HISTORIC PRESERVATION COMMISSION

SUBJECT: Historic Area Work Permit # 867436 REVISION #4: Basement Areaway and Entrance,
Porch Flooring, and Door Revisions.

Applicant: 19501 Georgia LLC (Luke Olson, Agent)
Address: 19 High St. (Parcel 700), Brookeville

**19 HIGH ST
LOT 4**

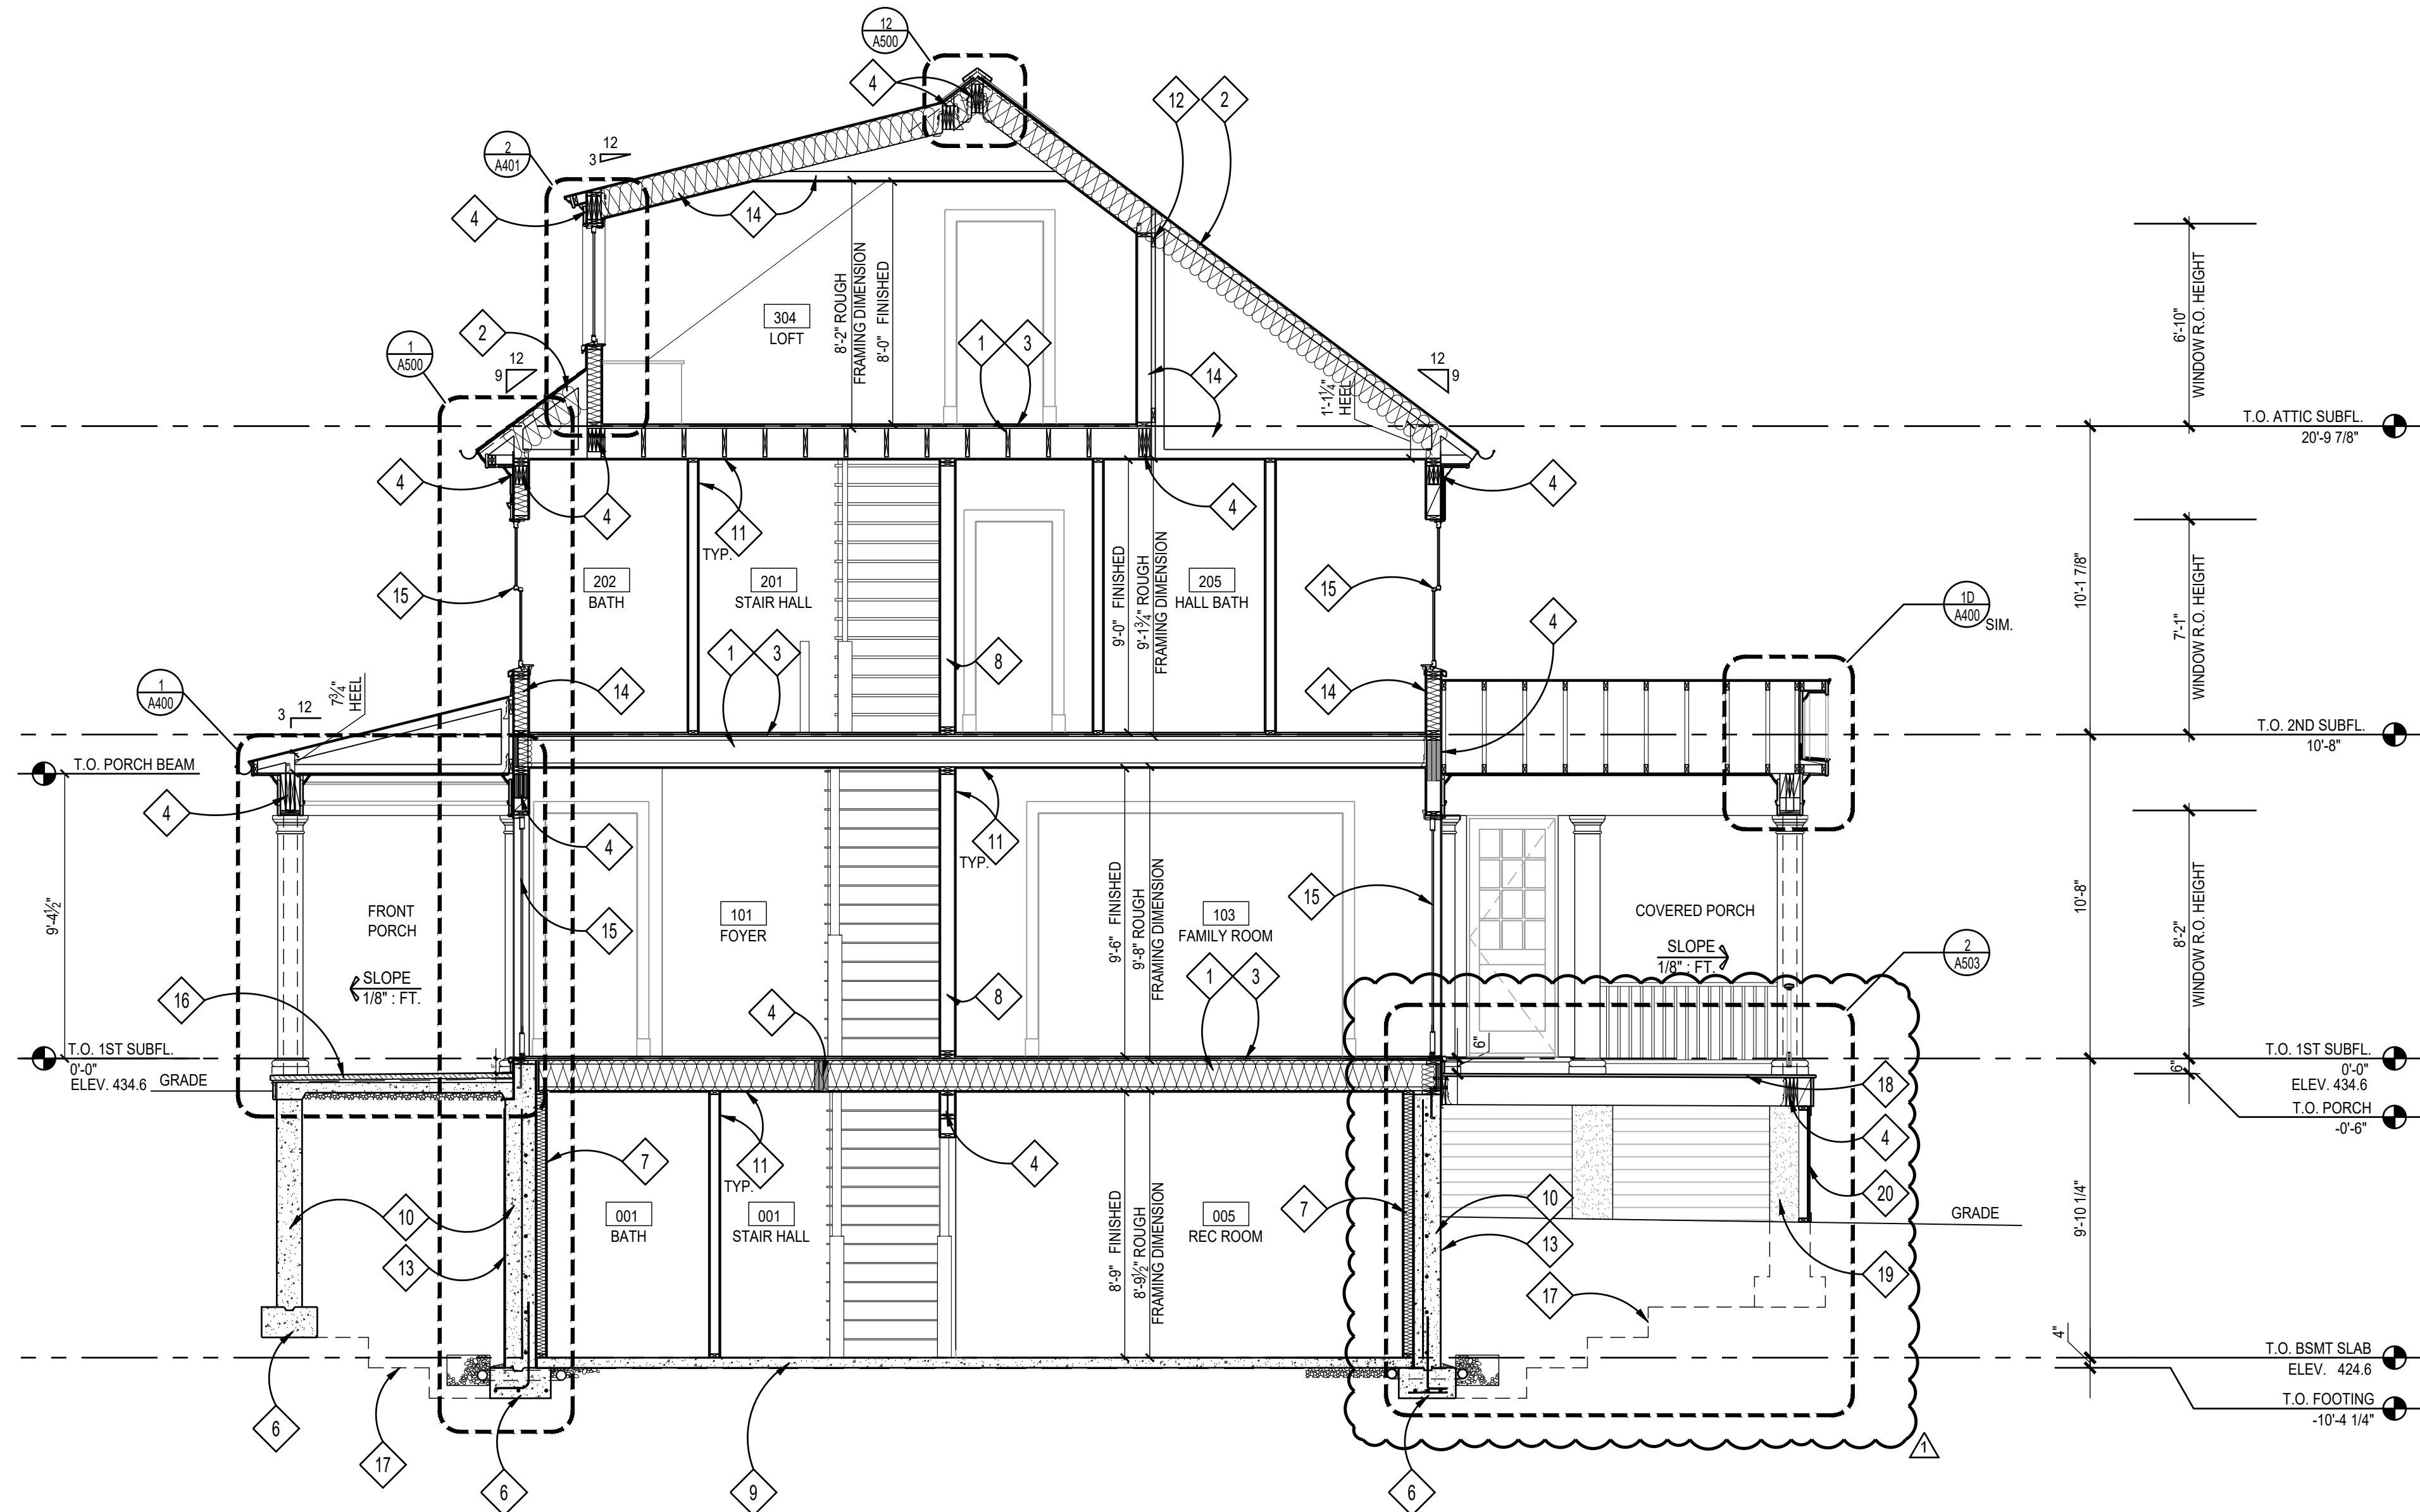
- CHANGE REAR PORCH FROM
FLAGSTONE ON CONC. TO DECKING ON
P/T JOISTS ON MASONRY PIERS
- ADD BSMT AREAWAY AND DOOR

**BUILDING
SECTION**

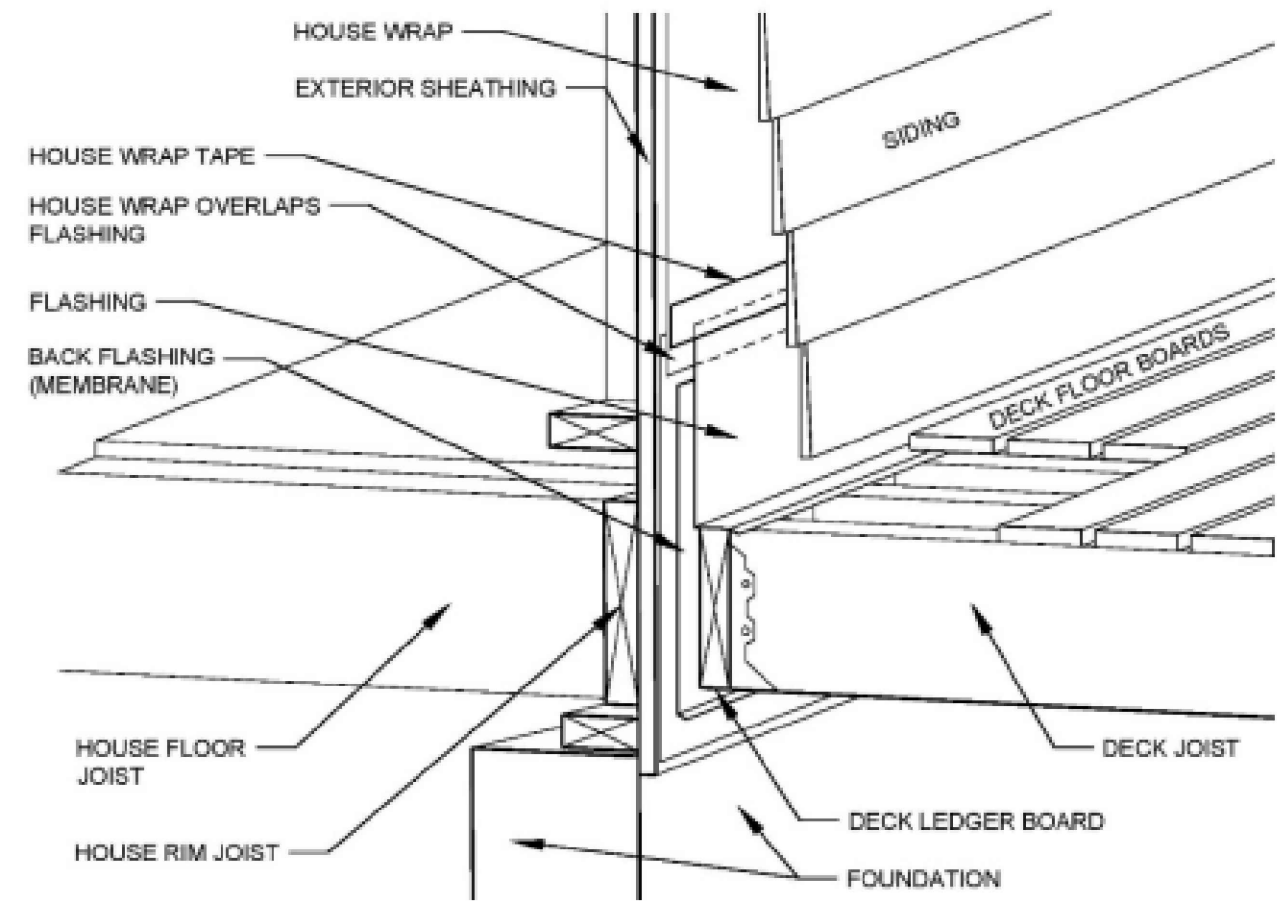
- CHANGE REAR PORCH FROM FLAGSTONE ON CONC. TO DECKING ON P/T JOISTS ON MASONRY PIERS
- ADD BSMT AREAWAY AND DOOR
